**TOWN OF OCEAN RIDGE
PLANNING & ZONING REGULAR MEETING
AGENDA**

**March 18, 2025 at 9:00 AM
Town Hall - Meeting Chambers**

To:	Planning & Zoning Board Members
From:	Corey O’Gorman, Town Planner
Meeting Date:	March 18, 2025
Subject:	11 Osprey Drive – Development Plan Review

PLAN REVIEW REPORT
11 Osprey Drive
11/11/24/Revision 01/10/25

A101

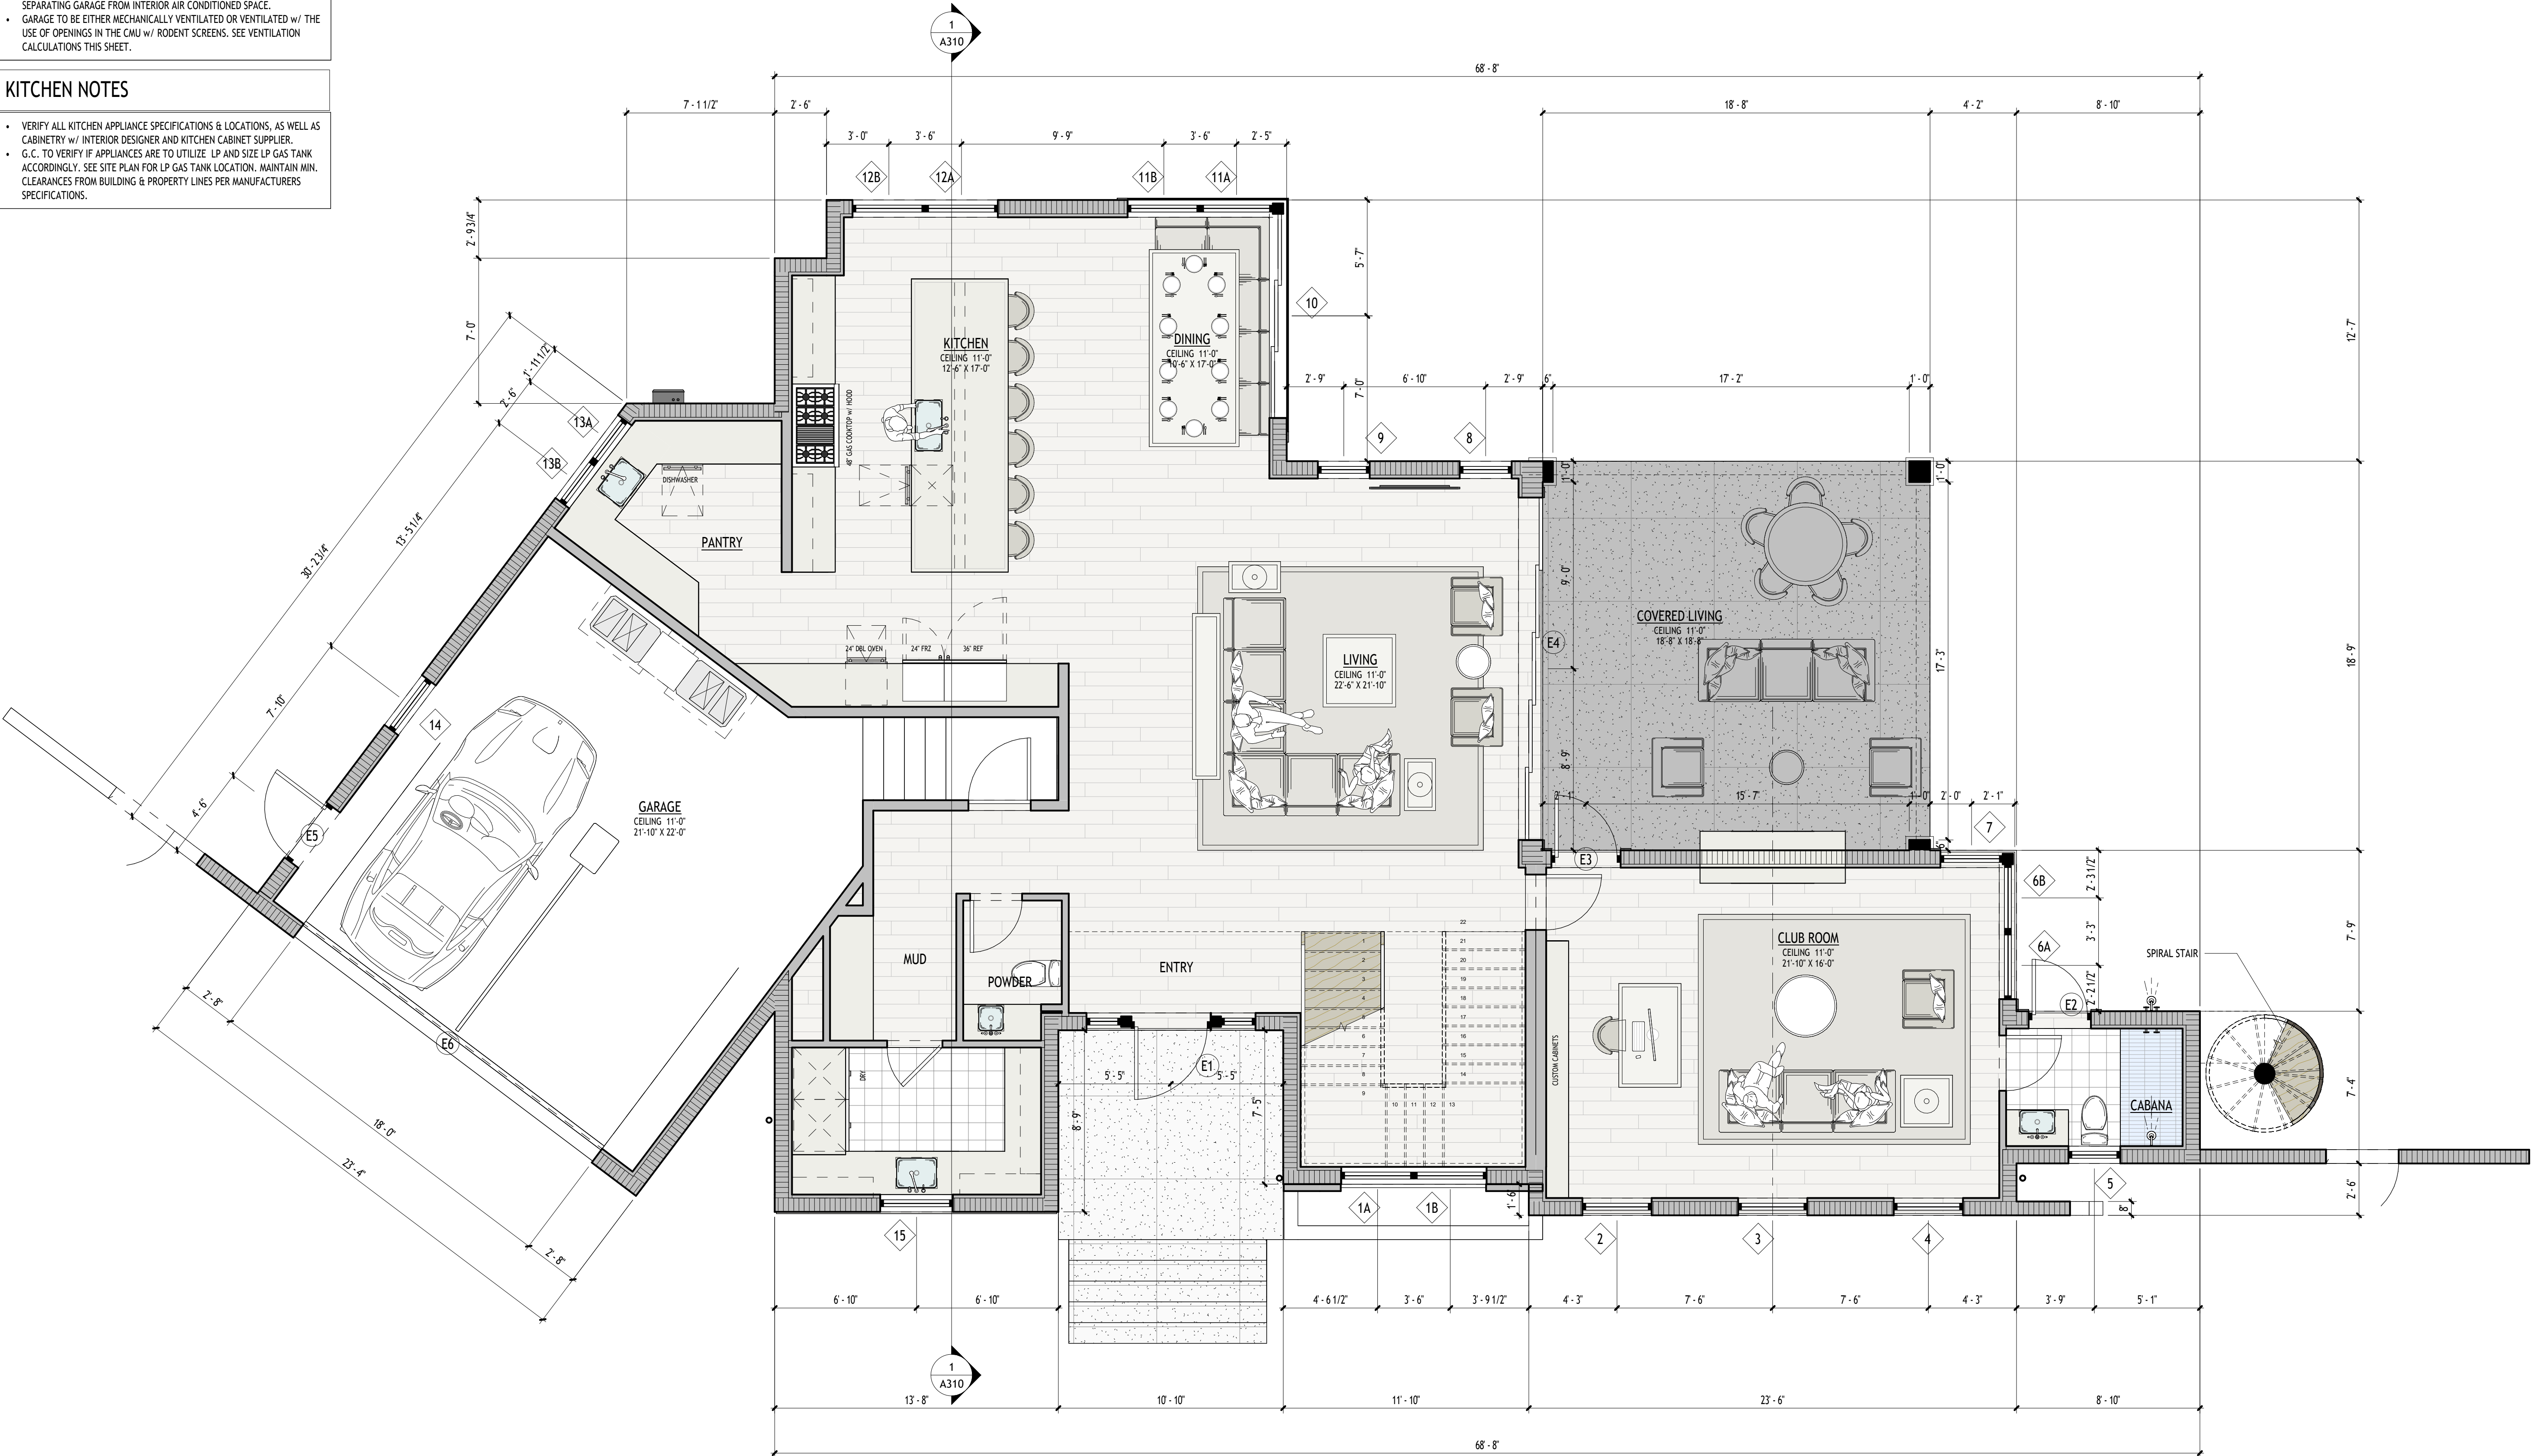
Section 64-42 (b) Background: This code section permits swimming pools to be setback a minimum of five feet from any side, rear or front property line, provided it is not enclosed and provided that it is not closer than five feet to the primary building. Although Sheet A101 shows a 5-foot setback to the property line, it does not include the dimension to the primary building.

Comment: Please revise Sheet A101 to include the setback from the principal building. **Condition of approval that the pool shall be setback a minimum of 5' from the building.**

Section 64-44 (c) Background: This code section addresses the maximum height of a walls, fences and hedges. Sheet A101 shows a 6' masonry wall with powder coated gate, and a 5' PVC fence. However, it is not clear where the 5' PVC fence begins and ends, and the height of the gate is not specified.

Comment: Please clarify where the proposed PVC fence begins and ends, and provide a height for the gate. **It is difficult to tell if the revision is in compliance. Condition of approval that all fencing shall comply with this code section and other applicable regulations.**

1 ROOF PLAN
1/4" = 1'-0"

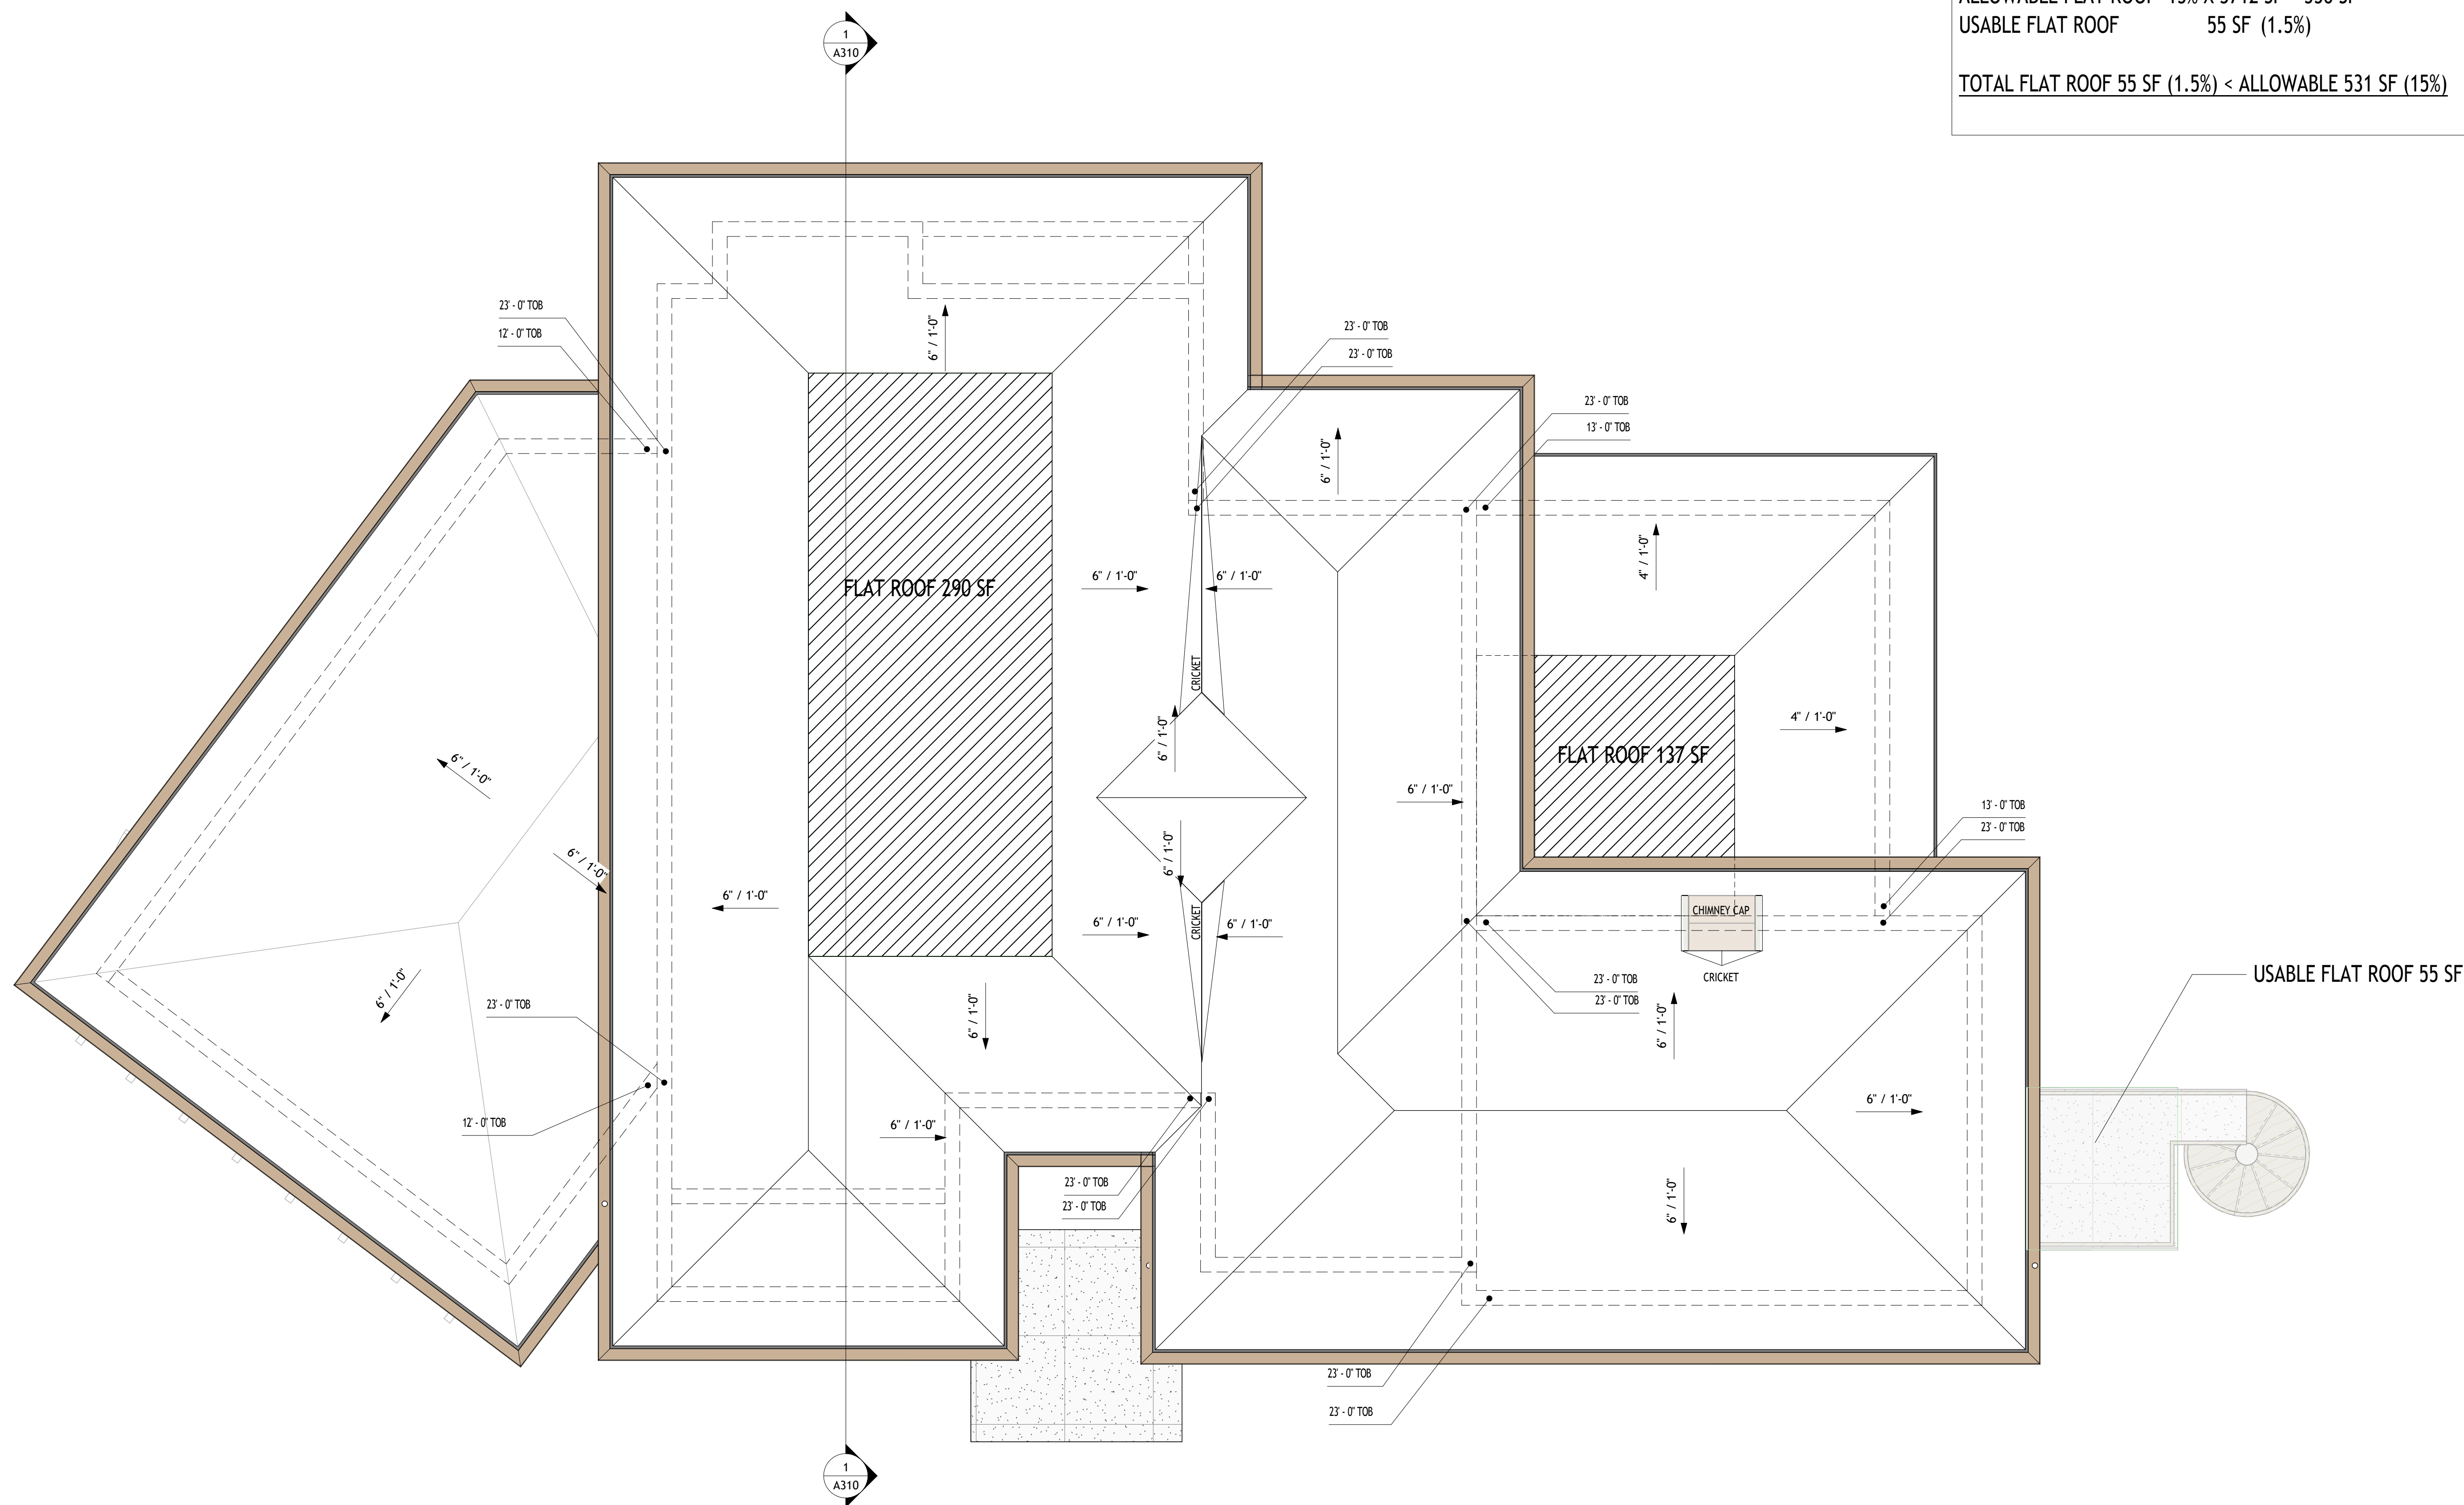
- Section 64-1(j)(5) Background: This code section specifies that the maximum lot coverage shall be 35 percent of the total lot area. Section 1-3 defines lot coverage as that portion of the area of a lot, expressed as a percentage, occupied by all buildings or structures which are roofed or otherwise covered and that extend more than three feet above the ground surface. The site data on sheet A100 shows lot coverage of 2933, but shows the roof area at 3533 in detail #3, and the Roof Plan sheet A210 shows total roof area of 3481.

- Comment: Please revise or clarify the roof area calculations and lot coverage to be consistent for purposes of determining the correct lot coverage. Revised comment: Detail 3 on sheet A100 and the Roof Plan Sheet A210 appear to show the roof area as 3,712 however the site data on Sheet A100 shows a proposed roof area of 2,933 SF. Condition of Approval: Revise Sheets A100 and A210 to show the correct roof area consistently.
